#### Zoning Case 23-02 (1617 U St)

# Shadow Study based on MU-10 By-Right Development Standards

Because the Applicant didn't do one

#### **Approximate Distance**

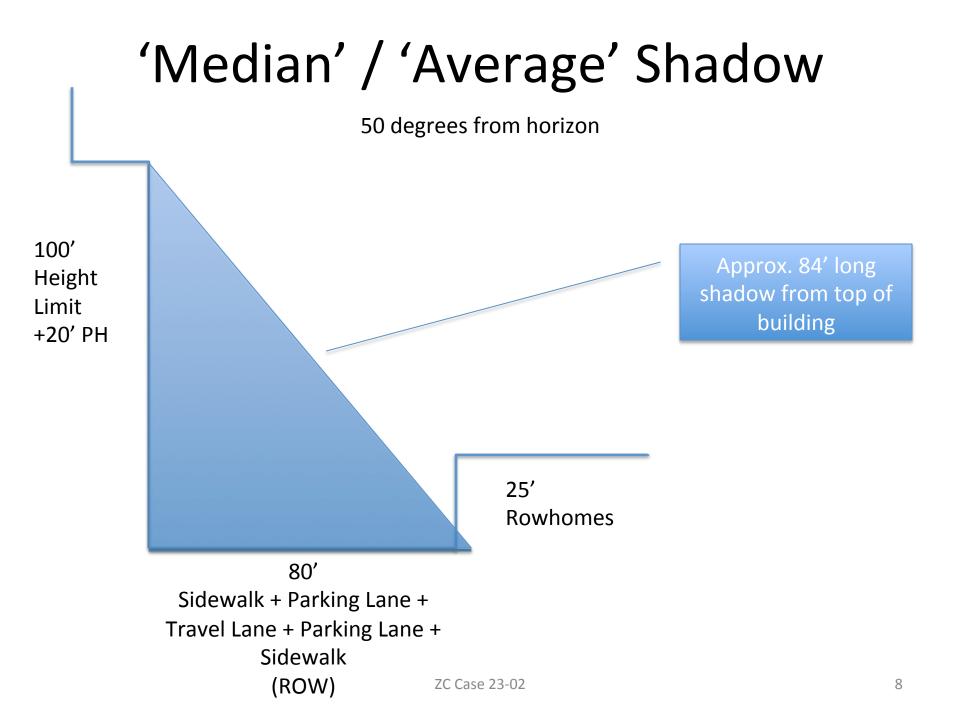
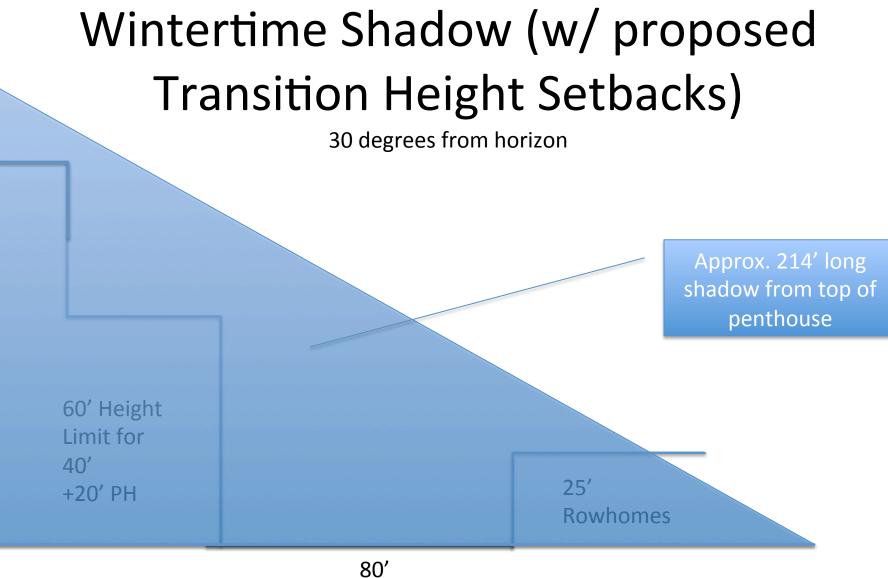
- Solar panels will be less useful
- Gardens will be at jeopardy
- Seasonal depression will be more likely
- The rowhomes are unable to be re-build to a higher density or height due to the underlying zoning and historical district
